Final Product/Process Change Notification

Document #:FPCN22766X

Issue Date:02 Jan 2020

Title of Change:	Qualify ASE Kunshan as alternative assembly site for SOIC7.	
Proposed First Ship date:	11 Apr 2020 or earlier if approved by customer	
Contact Information:	Contact your local ON Semiconductor Sales Office or <Marty.Paul@onsemi.com>	
PCN Samples Contact:	Contact your local ON Semiconductor Sales Office or <PCN.samples@onsemi.com>. Sample requests are to be submitted no later than 30 days from the date of first notification, Initial PCN or Final PCN, for this change. Samples delivery timing will be subject to request date, sample quantity and special customer packing/label requirements.	
Additional Reliability Data:	Contact your local ON Semiconductor Sales Office or <Shiela.Crosby@onsemi.com>	
Type of Notification:	This is a Final Product/Process Change Notification (FPCN) sent to customers. FPCNs are issued 90 days prior to implementation of the change. ON Semiconductor will consider this change accepted, unless an inquiry is made in writing within 30 days of delivery of this notice. To do so, contact PCN.Support@onsemi.com

OSPI: 3 Flag sizes

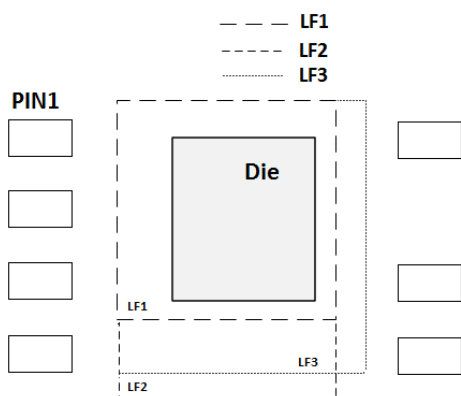
This FPCN is to notify customers that ON Semiconductor has completed qualification of ASE Kunshan (ASEKS) for the assembly of SOIC-7 products listed in this FPCN. This is a capacity expansion, and at the end of the FPCN approval cycle, these products may be dual sourced from either ASEKS or from the previously approved site, OSPI. All products listed will continue to be tested at OSPI. All package dimensions will still be within the existing ON Semiconductor published package case outlines. For assembly, the PN affected use 3 different LF (Lead frame) designs in OSPI. The flag (pad the die is attached to) has three sizes in OSPI. In ASEKS, there will be one flag size. BOM changes associated with this FPCN are shown here:		
Assembly Site	OSPI	ASEKS
Lead Frame	3 LF designs	1 LF design
Die Attach	CRM-1076WB	EN-4900GC
Mold Compound	G600	CEL9240

OSPI	ASEKS
Product marking change	Assembly Location: P	Assembly Location: AK

OSPI: 3 Flag sizes

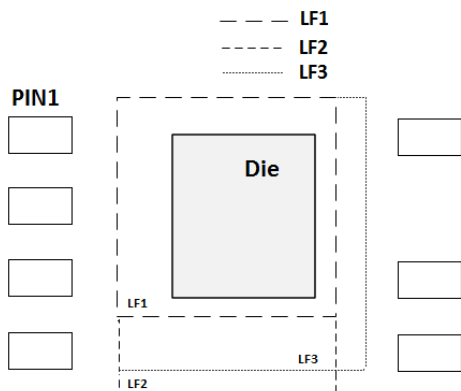
変更カテゴリ: アセンブリの変更		
変更サブカテゴリ: 材料の変更, 出荷/梱包/マーキング, 製造拠点の追加		
影響を受ける拠点:		
オン・セミコンダクター拠点:	外部製造工場 / 下請業者拠点:	
無し	ASEKS, China	
説明および目的:		
この FPCN は、オン・セミコンダクターが、この FPCN にリストされている SOIC-7 製品の組立に関して、ASE Kunshan (昆山) ASEKS の認定が完了したことをお客様に通知するものです。これによって生産能力が拡大され、FPCN 承認サイクルが完了した時点で、該当の製品は ASEKS または先に承認済みの拠点である OSPI のいずれかからのデュアルソースとなります。 リストされているすべての製品は、継続的に OSPI で検査されます。パッケージの寸法はすべて、既存のオン・セミコンダクターが公開しているパッケージケースアウトラインの規格内となります。 組立においては、影響する PN には 3 つの異なる LF (リードフレーム) 設計が OSPI で使用されます。フラッグ (ダイを接着するパッド) には、OSPI では 3 つのサイズがあります。ASEKS では、フラッグのサイズは 1 つです。今回の FPCN に関連する BOM の変更を以下に示します:		
組み立て拠点	OSPI	ASEKS
リードフレーム	3 LF designs	1 LF design
ダイ接着剤	CRM-1076WB	EN-4900GC
モールド・コンパウンド	G600	CEL9240

OSPI	ASEKS
製品マーキング変更	Assembly Location: P	Assembly Location: AK
